**GOVERNMENT OF THE DISTRICT OF COLUMBIA
DEPARTMENT OF TRANSPORTATION**

MEMORANDUM

DATE: February 16, 2017

SUBJECT: BZA Case No. 19450 - 3320 Idaho Ave NW - Ward 3 Emergency Shelter

Figure 1 - Site Access (Source: Ayers Saint Gross)

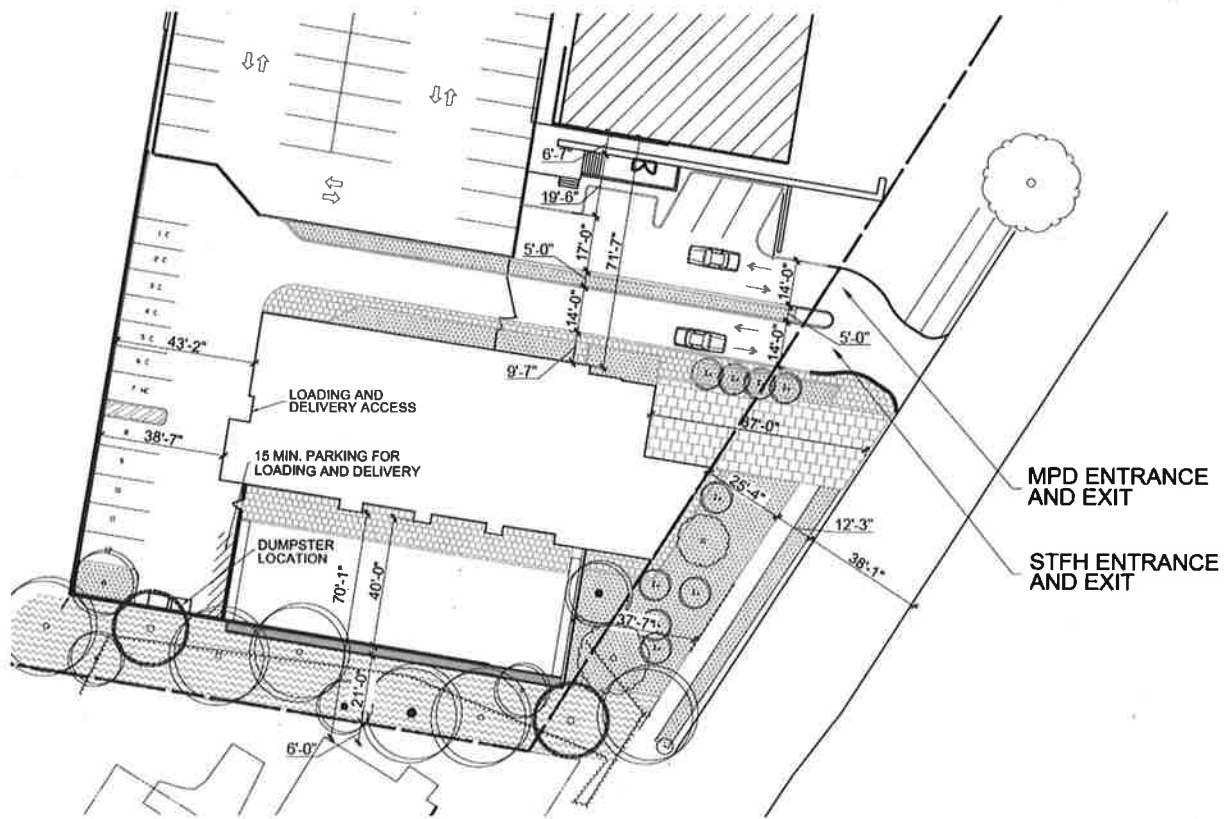
The site is located on an improved lot bounded by Idaho Avenue to the east, Newark Street to the north, community recreation uses to the west, and residential properties to the south. A Metropolitan Police Department (MPD) Second District Headquarters and surface parking lot is located on the site. The Applicant proposes to maintain the MPD building and replace the surface parking lot with the proposed shelter and a multi-level vehicle parking garage. Pedestrian access will occur from Idaho Avenue via an accessible path to the main entrance. The proposed vehicular access will shift to the north of the existing curb cut on Idaho Avenue, which will be closed. The proposed curb cut will result in the removal of a healthy street tree, which DDOT will not support, and potentially healthy special trees. Relocating the proposed curb cut closer to the existing Metropolitan Police Department building is a more appropriate design solution to retain the street tree and special trees. Final curb cut design will be handled through the public space permitting process.

The proposed curb cut will result in the removal of a healthy street tree, which DDOT will not support, and potentially healthy special trees. Relocating the proposed curb cut closer to the existing Metropolitan Police Department building is a more appropriate design solution to retain the street tree and special trees. Final curb cut design will be handled through the public space permitting process.
